COFFMAN ESTATES SUBDIVISION

APPLICATION NUMBER 8 DATE March 1, 2007

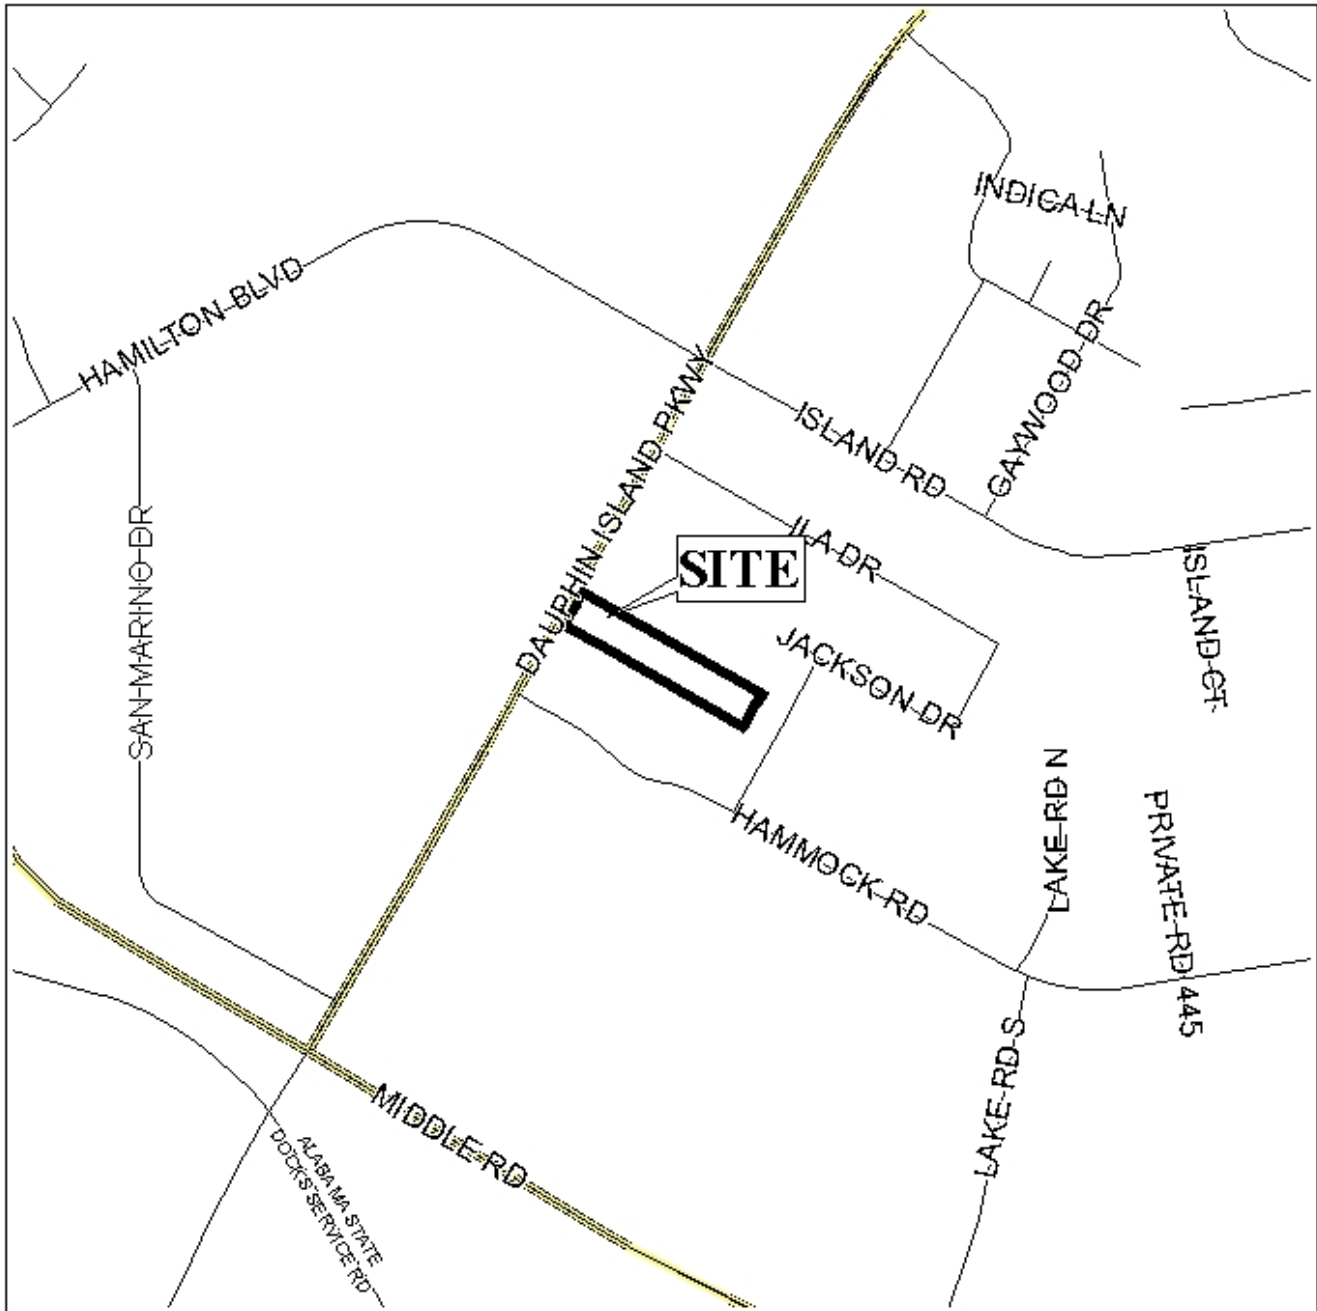
The site fronts Dauphin Island Parkway, a planned major street; however, the current right-of-way width of 80-feet does not meet the minimum width of 100-feet recommended for this major street, according to the Major Street Plan. Therefore, the setback of an additional 10-foot from the right-of-way should be required. The additional setback from the right-of-way will require the eastward adjustment of the 25-foot minimum building setback line to 35-feet (75-feet from the centerline of Dauphin Island Parkway), in accordance to Section V.D.9. of the Subdivision Regulations.

Proposed Lot 3 will be a flag lot with only 25-feet of frontage on Dauphin Island Parkway. There are no Planning Commission-approved flag-lots in the immediate vicinity; however, since the existing lots are 100-foot wide, any resubdivision of these lots would be a flag-shaped lot, a waiver of Sections V.D.1. and V.D.3. of the Subdivision Regulations will be required, and it is recommended that a note also be placed on the plat stating that no future subdivision of Lot 3 is allowed until additional frontage on a public street is provided.

It should be noted that since Lot 3 will be a legal lot of record, the removal of the 25-foot non-exclusive easement for ingress and egress from the Final Plat would be required.

As illustrated on the preliminary plat the minimum building setback line for Lot 3 should be corrected to illustrate the 25-foot minimum building setback line from the end of the flag portion of the lot.

With a waiver of Section V.D.1. and V.D.3., the plat is recommended for Tentative Approval, subject to the following conditions: 1) the setback of an additional 10-foot from the right-of-way along Dauphin Island Parkway, and a 35-feet (75-feet from the centerline of Dauphin Island

Parkway), in accordance with Section V.D.9.; 2) provision of a certification letter from a licensed engineer to the Planning Section of Urban Development, certifying that the stormwater detention and drainage facilities comply with the City of Mobile stormwater and flood control ordinances, prior to the issuance of any permits; 3) labeling of all lots with size in square feet, or provision of a table with the lot size information on the plat; 4) placement of a note on the Final Plat stating that any lots which are developed commercially and adjoin residentially developed property must provide a buffer, in compliance with Section V.A.7. of the Subdivision Regulations; and 5) the correct placement of the 25-foot minimum building setback line for Lot 3 on the Final Plat.
